**Code Amendment Proposal: Applicability of LGVC Overlay District for Replacement Parking**

# **ATTACHMENT 2**

## **Preliminary On-Site Parking Replacement Plans with Written Summaries**

Re: LU 17-0028 Proposed Code Amendments for Constrained Sites

**Mozena Law Office (15853 Boones Ferry Road)**

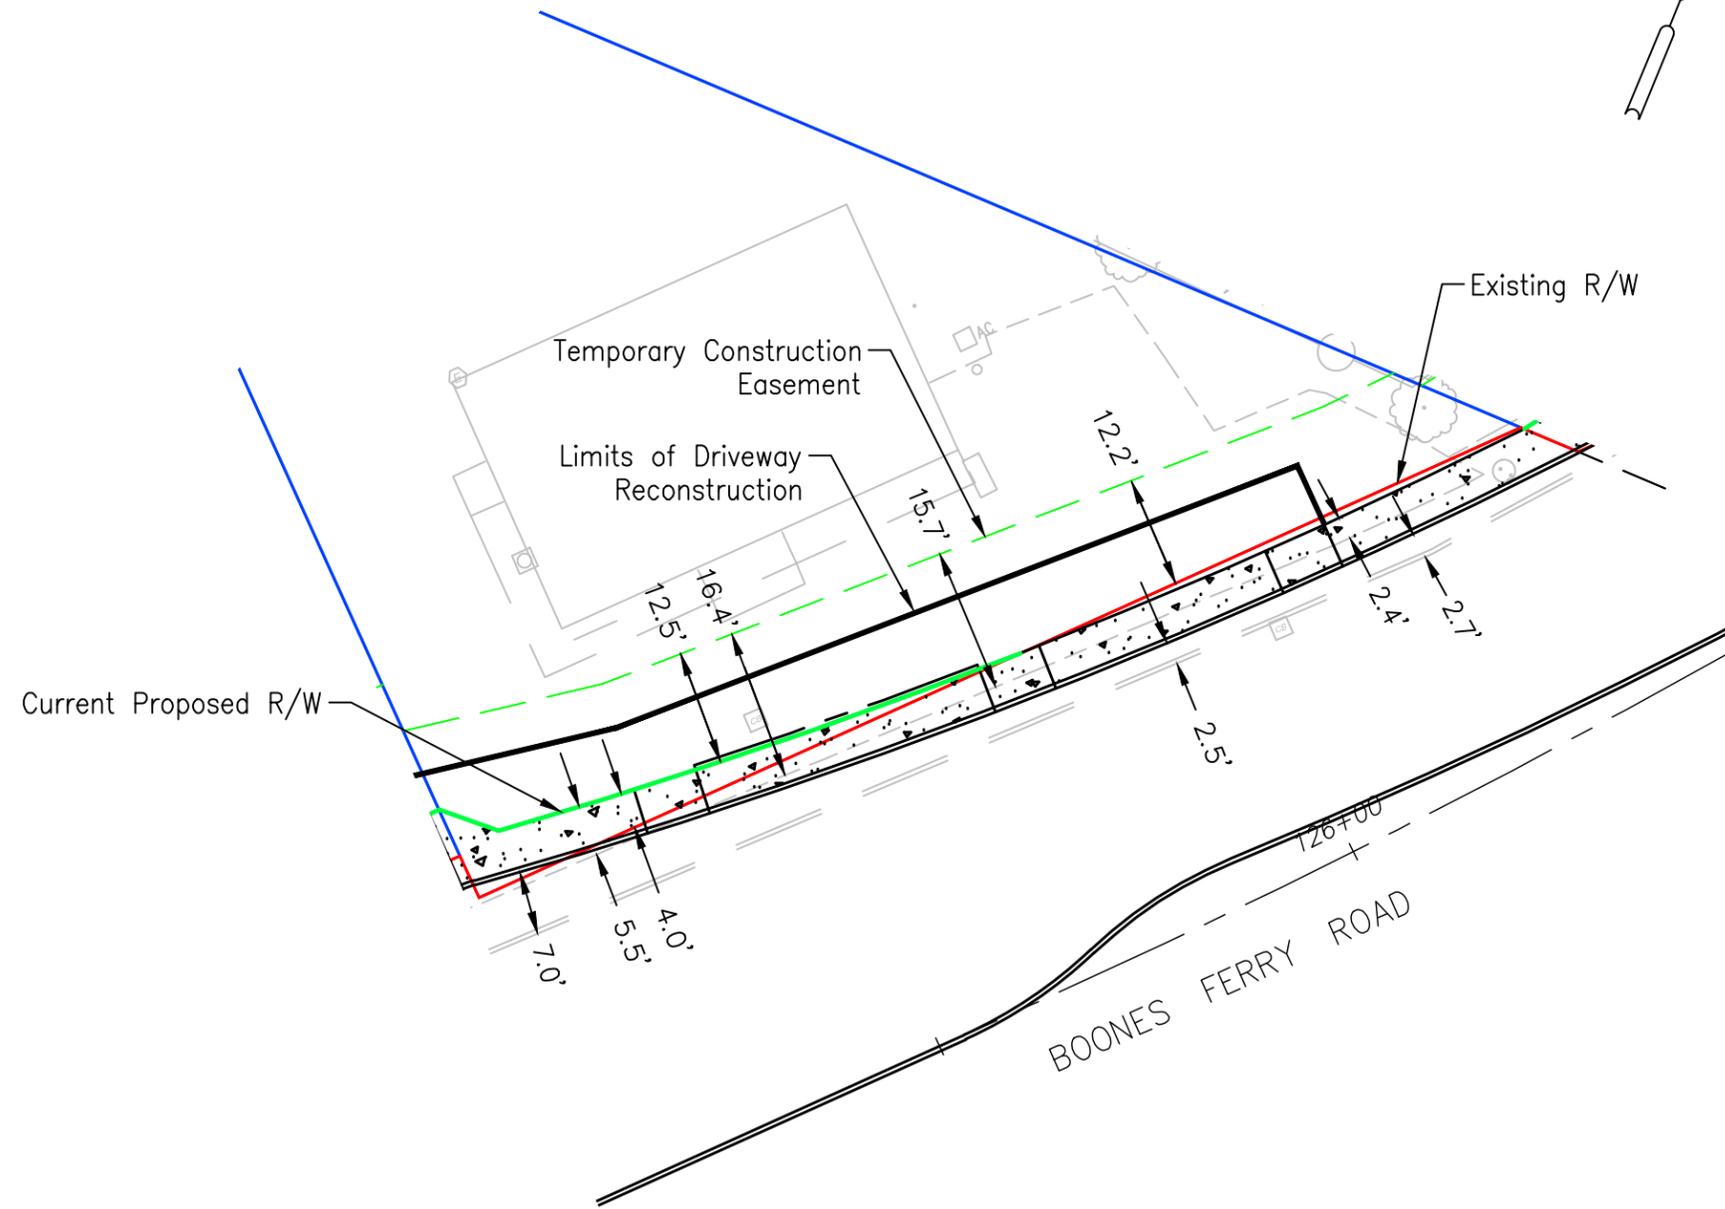
Re: second bullet point: There are not **2 lost parking spaces but 4 to 6 due to parking access reduction.**

Re: third bullet point: There needs to be **substantial reduction in landscaping and removal of trees replacing them with arborvitae ( or non-area consuming vegetation) for buffering** in order to increase parking area in this smaller lot.

Re: fourth bullet point: This bullet point needs to be removed.

1. Removal of maple trees which are in poor condition and which fail to buffer school and commercial area. Replacement buffering would be an improvement and supply better buffering with Arborvitae ( or non-area consuming vegetation).
2. Border landscaping area to be leveled and increase parking area and improve buffering with Arborvitae (non-area consuming vegetation) between school and commercial area
3. In order to accommodate Parking space and access area replacement, additional asphalt will be required in multiple landscaped or dirt areas especially near school boundary. Parking may require placing the HVAC in a different location. This is in addition to changing landscaping and replacement buffering. A corner cut of curbing surrounding the structure will be necessary to allow for access to back parking.

[Note: Mr. Mozena’s letter also addresses the written summary for the replacement parking plan for his property at 15835 Boones Ferry Rd (see **Attachment 3.a**). The plan and written summary for Mr. Mozena’s property reflect the current appraisal/city offer; agreement on a compensation package has yet to be reached. Mr. Mozena’s letter with requests has been forwarded to Brant Williams, who represents the City in the property acquisition process.]

# Gubanc's Restaurant (33)

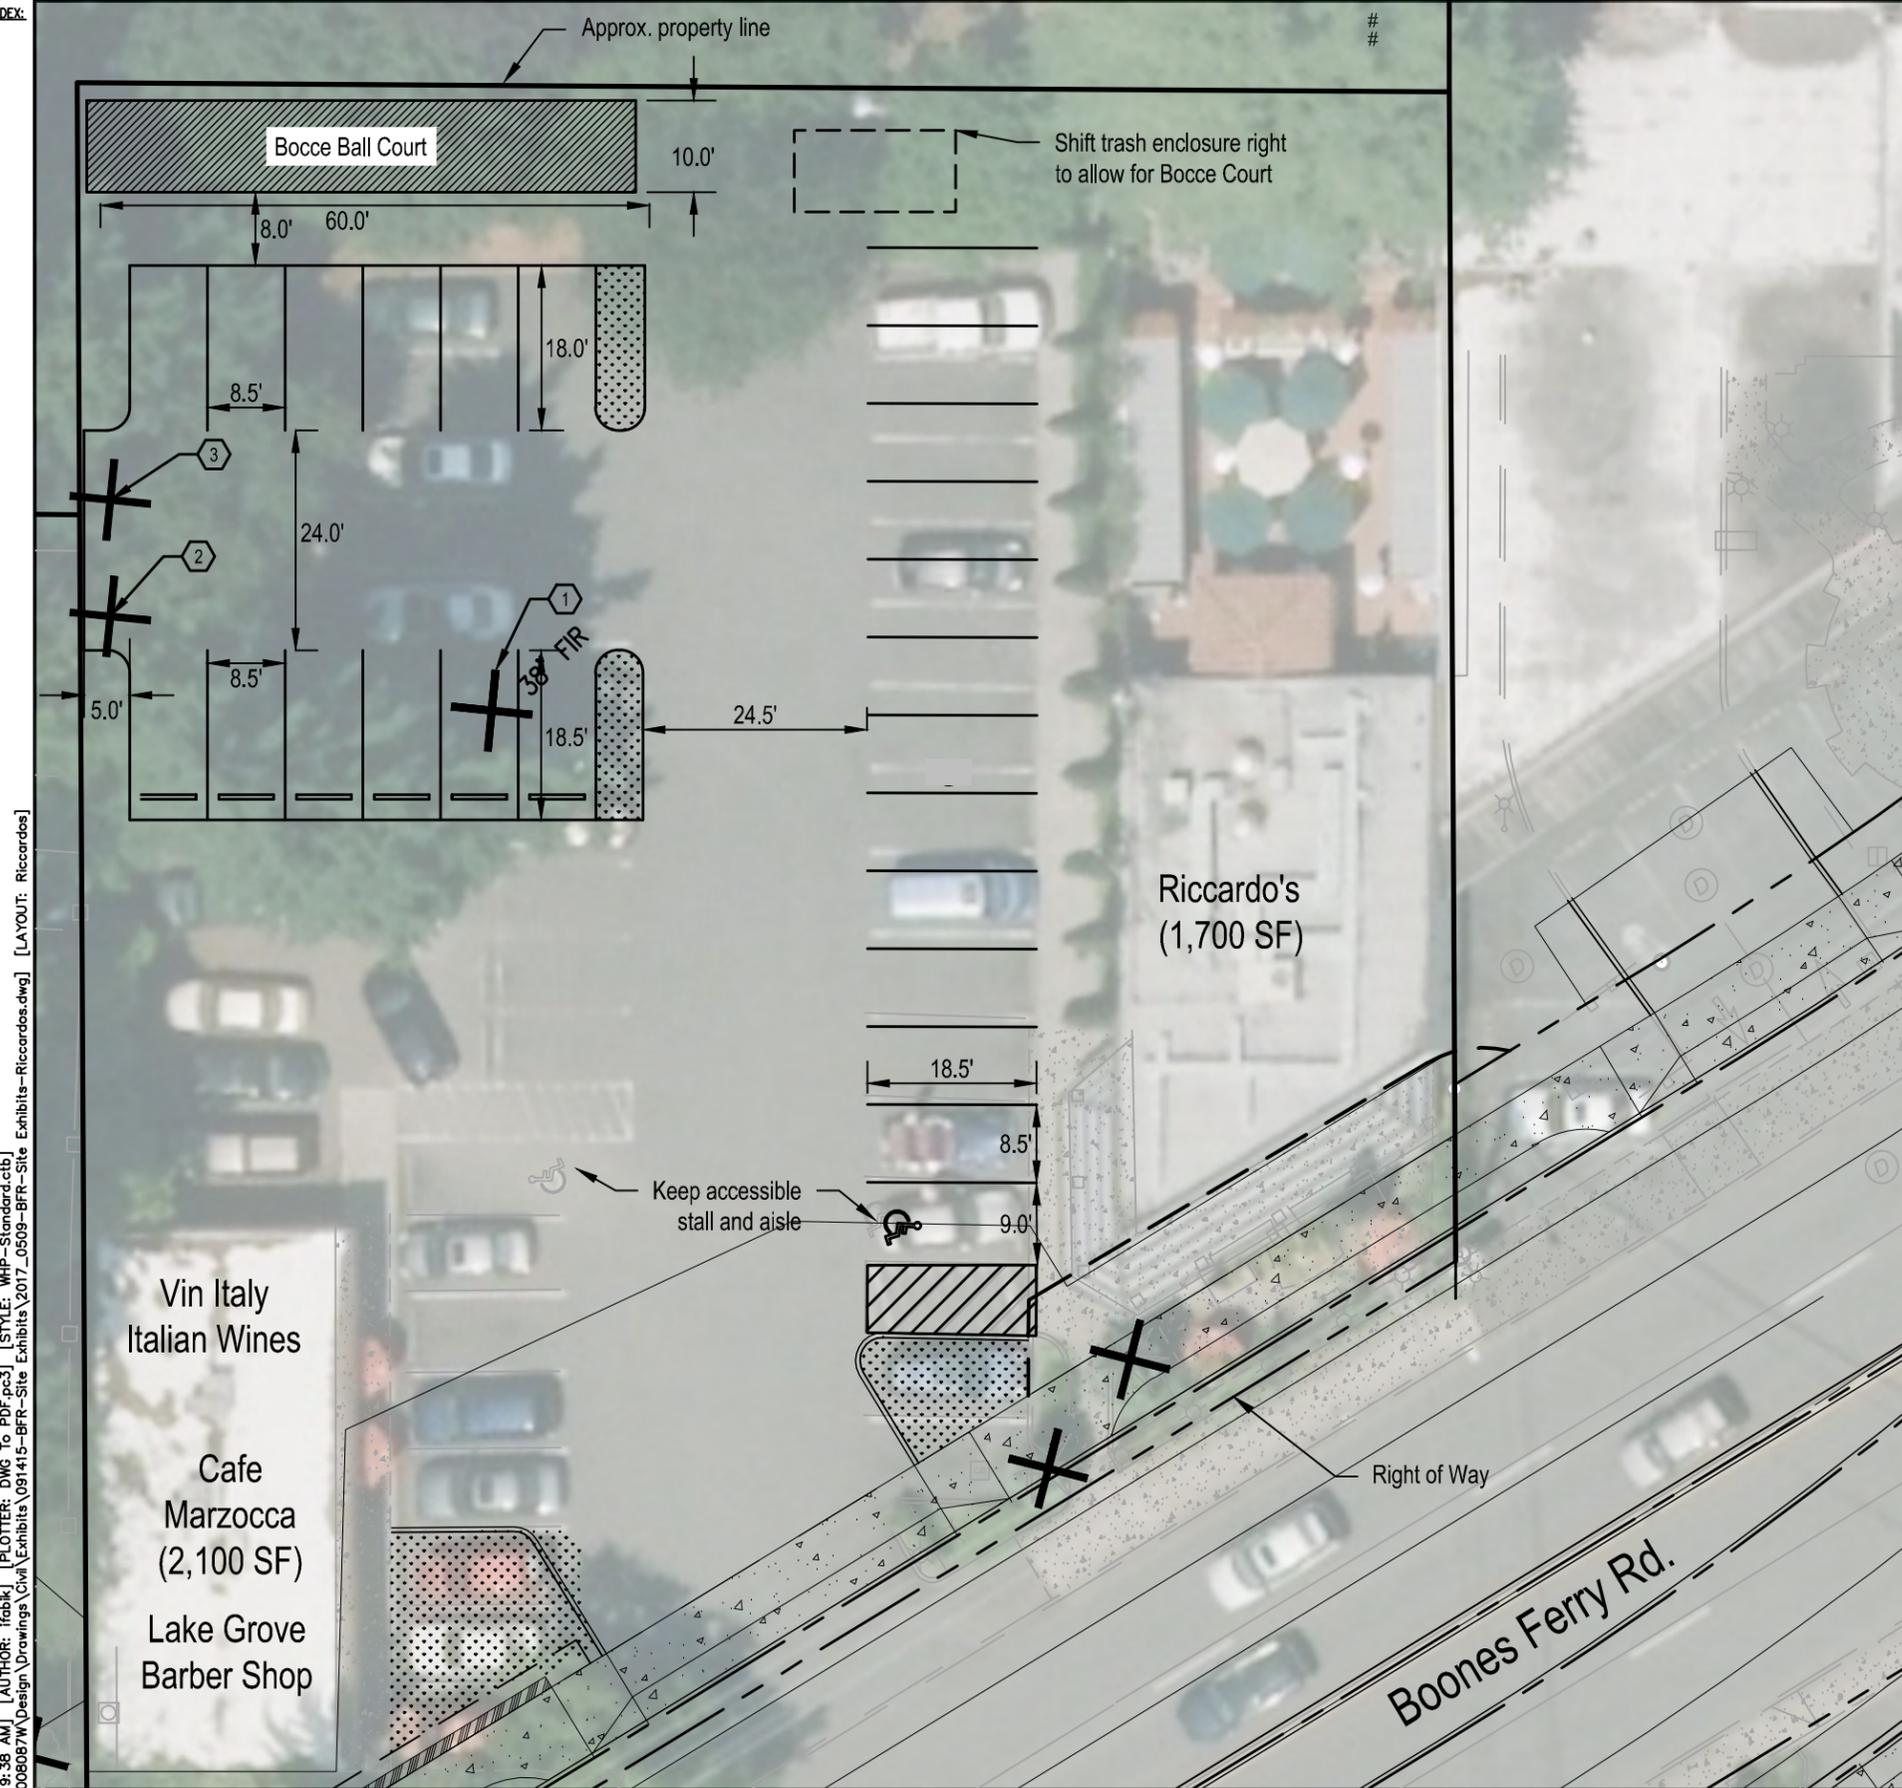
A comment noted an error with the proposed location of the two replacement parking spaces (**Attachment 3.b**). Per LOC 50.05.007.6.f.i, a 10-ft. landscaped and fenced buffer is required where a commercial property abuts R-7.5 or R-10 properties. For properties bounded by Bryant Rd., Boones Ferry Rd., Reese Rd., and the ROW north of Sunset, there is an existing 6-ft. pedestrian ROW area separating the commercial land from the abutting residential properties to the south. For these properties, the LGVC Overlay standards only require a 5-ft. landscaped and fenced buffer [LOC 50.05.007.6.f.v]. As a result, the entire offset is *11 feet*: 6-ft. pedestrian ROW and 5-ft. on-site buffer. As Ms. Falson notes, the current replacement plan for Gubanc’s Restaurant shows existing parking along the south property line incorrectly; those spaces are actually within the 6-ft. pedestrian ROW (see **Attachment 2 – page 7 and Attachment 3.b**). Using the existing parking as a baseline, the proposed parking spaces appear to be set back less than the required 11 ft. from the outside edge of the 6-ft. pedestrian ROW. Staff will work with the consultant to ensure the correction is incorporated in the final replacement parking plan for the Planning Commission public hearing on August 14, 2017.

Also, the Gubanc's Restaurant Preliminary On-Site Parking Replacement Plan is inaccurate. The setbacks for the current parking spaces are not shown correctly. It would be helpful to have an updated site plan, showing the actual position of existing parking spaces and dimensions.

# Keller Williams (46)

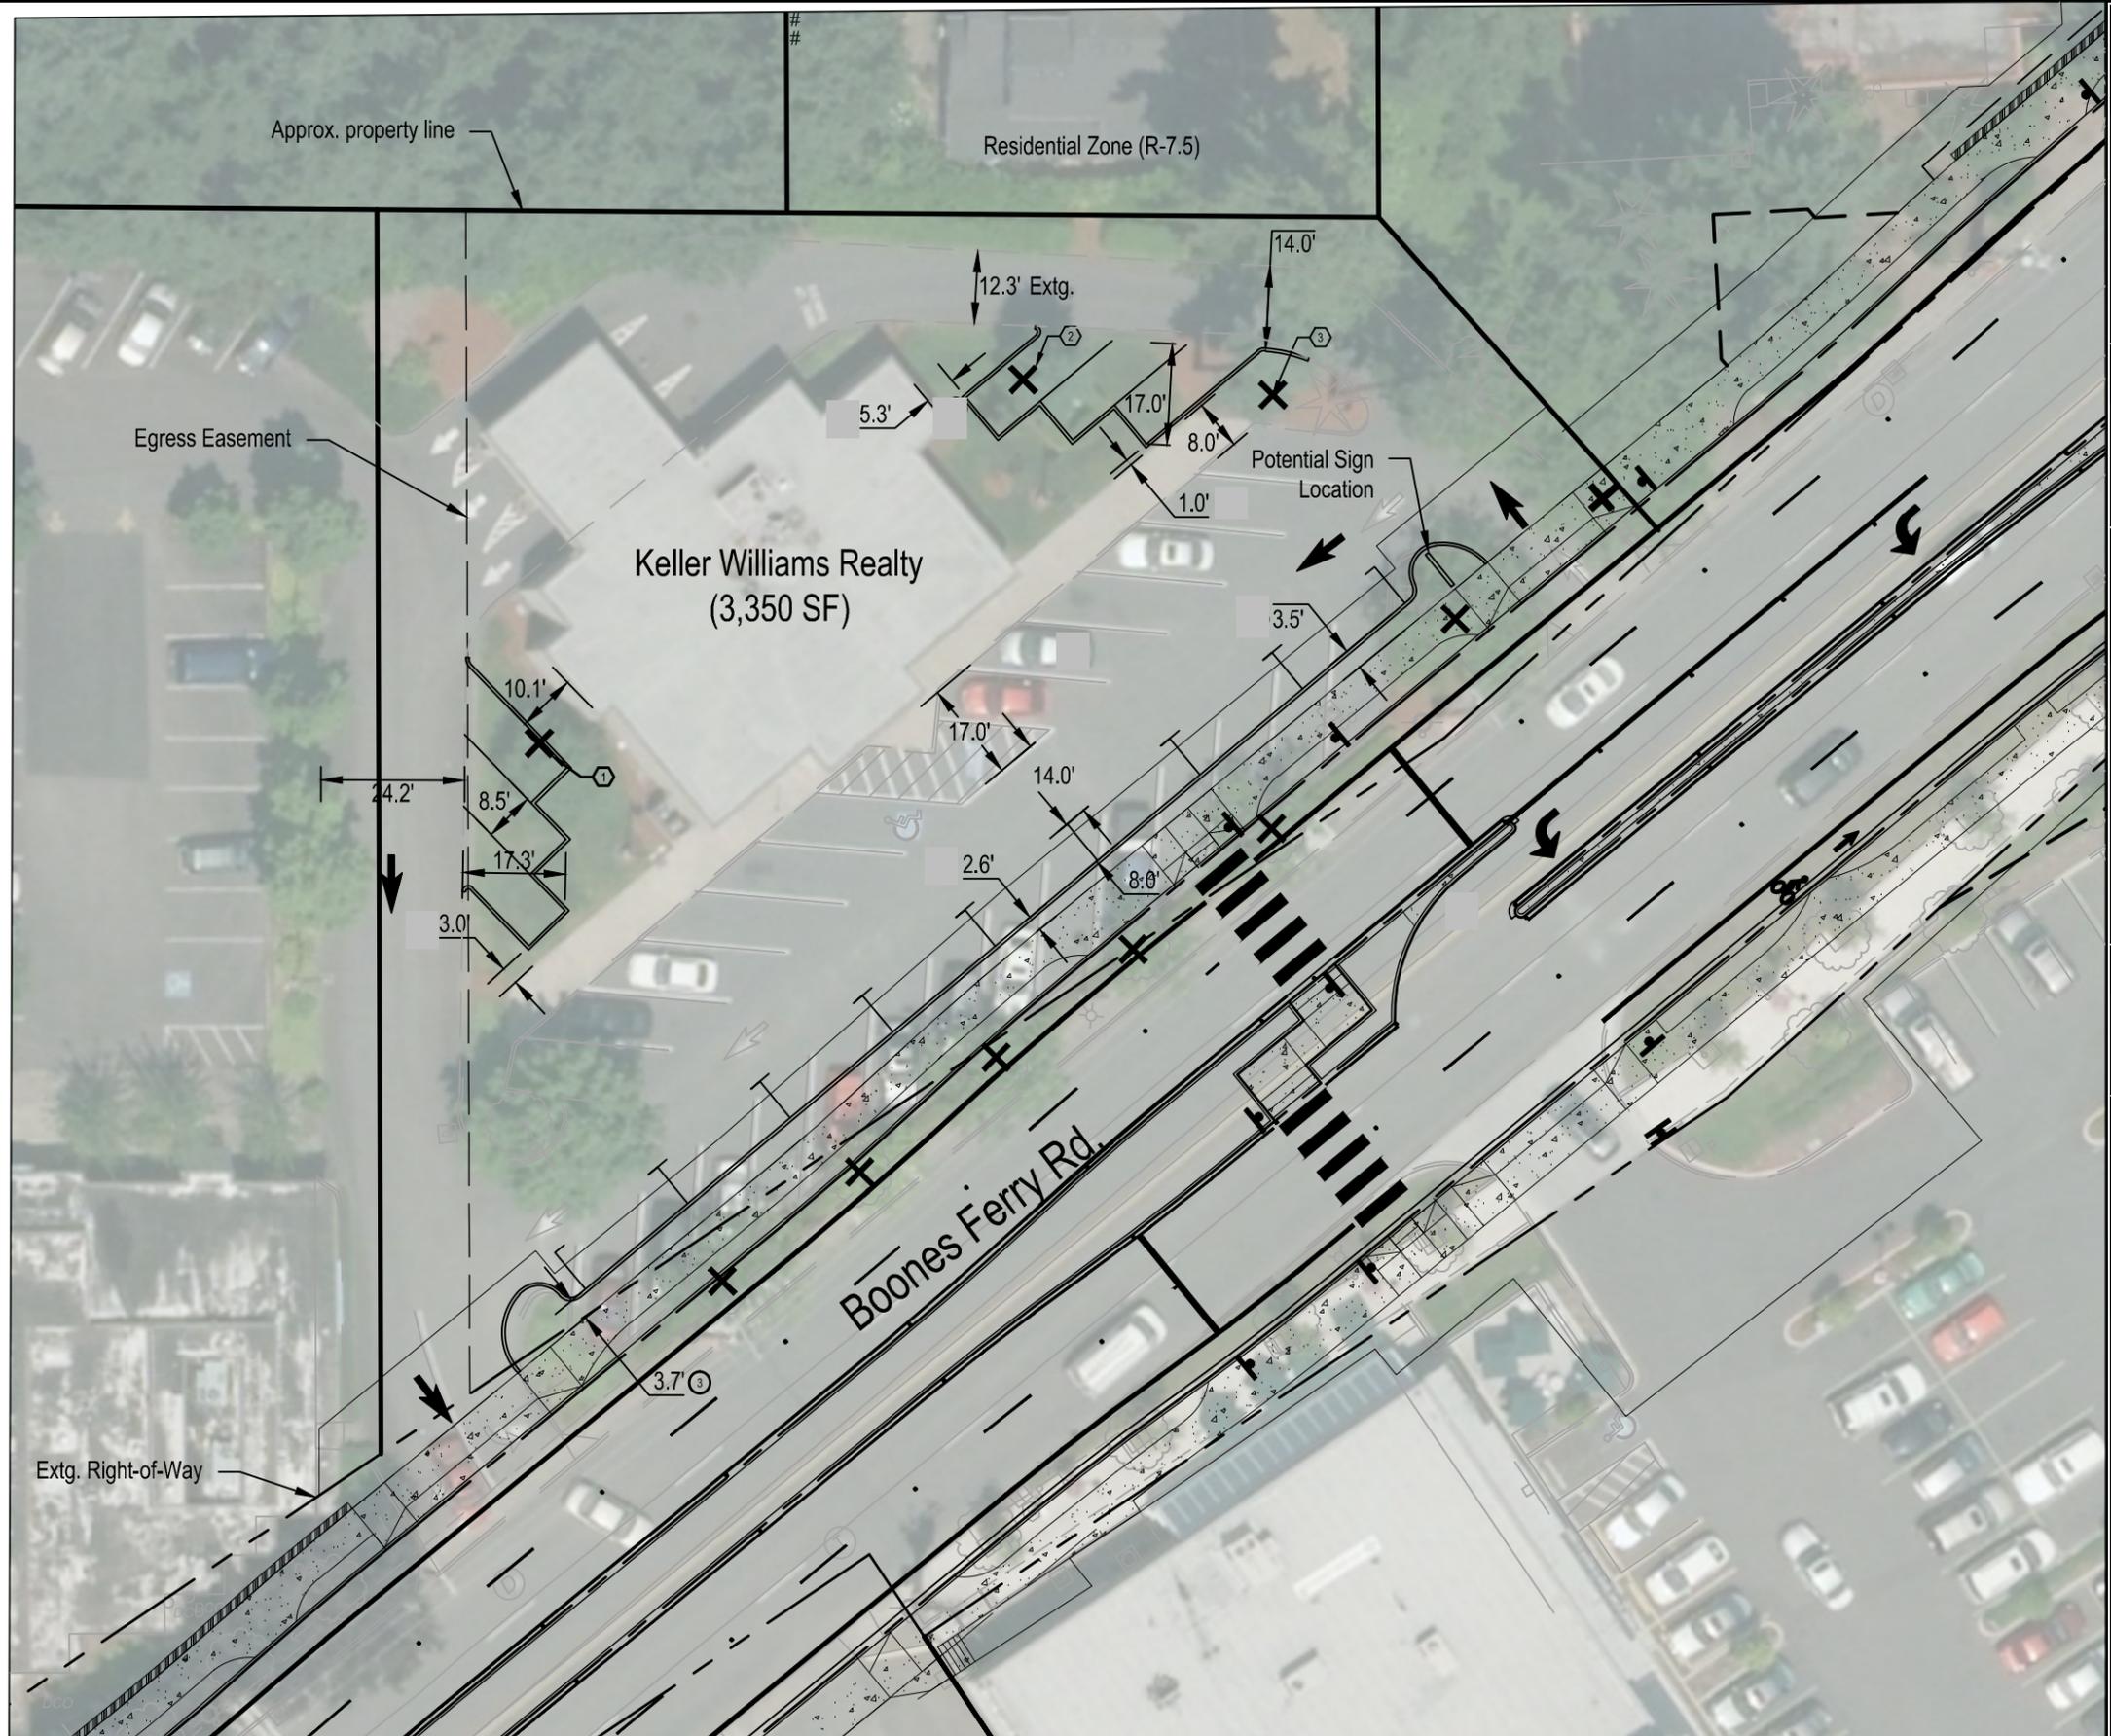
Two of the comments received during the public review draft focused on removal of trees for the replacement parking (see **Attachments 3.b and 3.c**). In the design of the BFR improvements and associated replacement parking, the City endeavored to minimize tree removal. However, the constrained nature of most of the affected properties makes that difficult; this is especially problematic on the Jenike Property (**Attachment 2 – pages 12-13**) and the Keller Williams
